SERVICE BULLETIN

SB1270

| VEHICLE MODEL | : T2145, C2045, CX45 |
| SUBJECT | : To change not properly heat-treated axle shafts |

Procedure: Axle shaft change out procedure

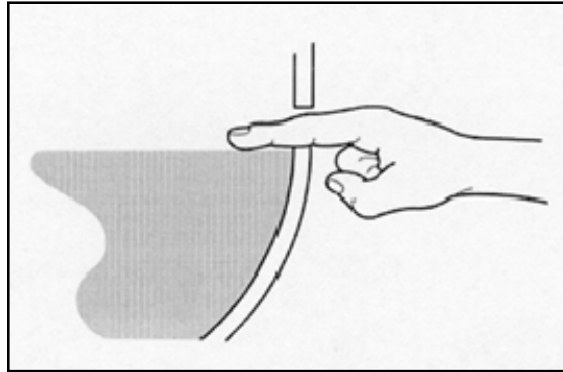
- Axle manufacturer Dana has informed Van Hool of a quality issue on the axle shafts of some drive axles. The affected axle shafts have been incorrectly heat treated what can result in early failure if the shafts are subjected to extreme or adverse operating conditions.
- To address this issue, Dana and Van Hool are conducting a field change program to replace these axle shafts. Terms and conditions are explained further on under "Warranty".
- Owners and operators of the affected units should replace the axle shafts.
- Refer to the step-by-step instructions explained in this Service bulletin.

1. Remove the 8 x Verbus Ripp retaining screws securing the axle shaft to the hub.
2. Place a drip tray or spill cloth under the flange end of the axle shaft to catch any oil which may be lost as the axle shaft is extracted.
3. Insert 2 x M10 x 1.5 “jacking screws” into the 2 threaded holes in the axle shaft flange. This will pull the axle shaft flange away from the hub face.
4. Pull the axle shaft from the axle.
5. Clean the face of the hub and apply a thin bead of soft sealant (Loctite 518 or similar).
6. Identify the correct position of the axle shafts. On the figure below it is shown that the shorter shaft part No.834203 is fitted at the LH side of the vehicle/axle. The longer shafts part No.834202 is fitted at the RH side of the vehicle/axle.

7. Insert the new axle shaft into the axle, aligning the axle shaft splines with the differential side gear. Some rotation of the axle shaft will be necessary to align the splines.

8. Fit the 8 x Verbus Ripp axle shaft retaining screws and tighten to a torque of 314 to 346 Nm (230 to 255 ft.lbf).
9. When both axle shafts have been replaced check that the axle lube is level with the bottom of the filler hole. Top up the axle oil level if necessary.
10. Refit the filler plug and tighten to a torque of 54 to 68 Nm (40 to 50 ft.lbf).
